SLINGSHOT

ARTICLE: T-16-01-01
DATE: Jan 14, 2016

SUBJECT: SLINGSHOT – HOOD BUMPER REPLACEMENT KIT

MODELS: ALL 2015-2016 SLINGSHOT MODELS

HOOD BUMPER KIT (PN 2206305)

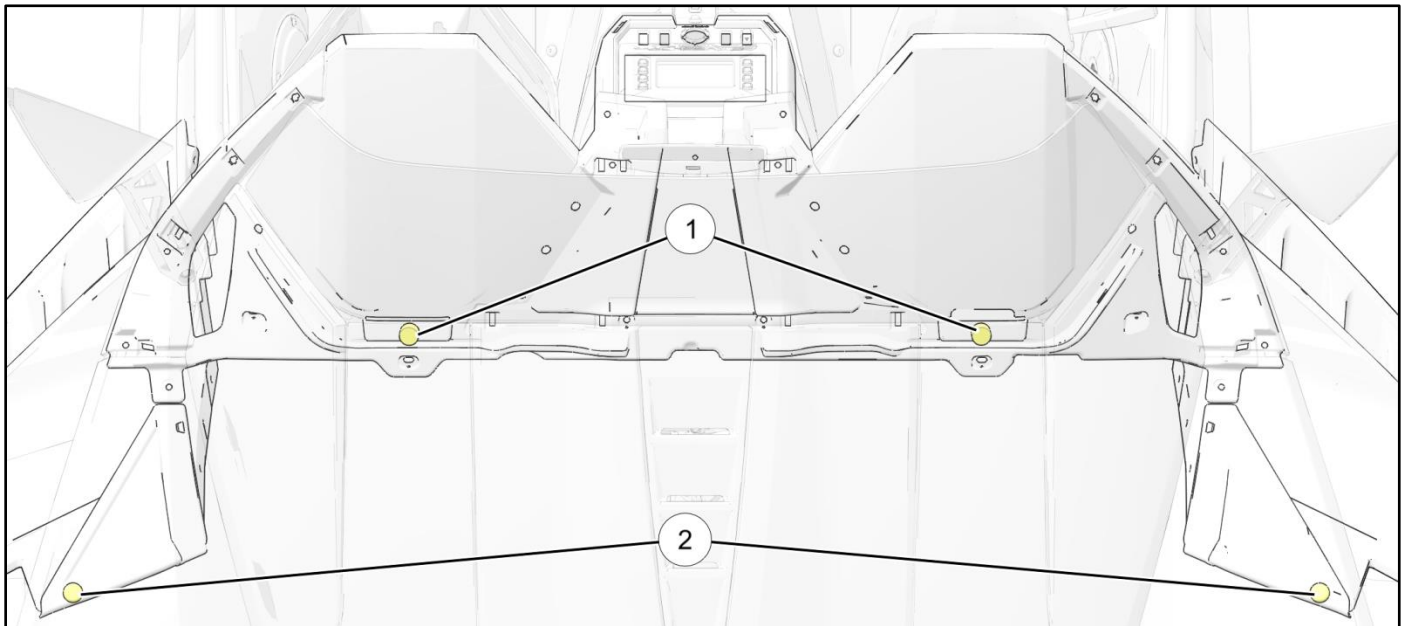
The Slingshot Division of Polaris Industries has developed a hood bumper replacement kit for all 2015 and 2016 Slingshot models. The original hood isolator brackets are composed of a rubber pad adhered to a metal support bracket. In some cases, the rubber pads may separate from the metal support bracket due to heat and vibration.

If a vehicle is experiencing separation of the rubber pad from the metal support bracket, the hood bumper replacement kit (PN 2206305) should be installed. The kit includes four rubber isolation bumpers and installation instructions and is intended to be used with the existing support brackets mounted to the hood. The Polaris Online Electronic Parts Catalog has been updated to include the new hardware.
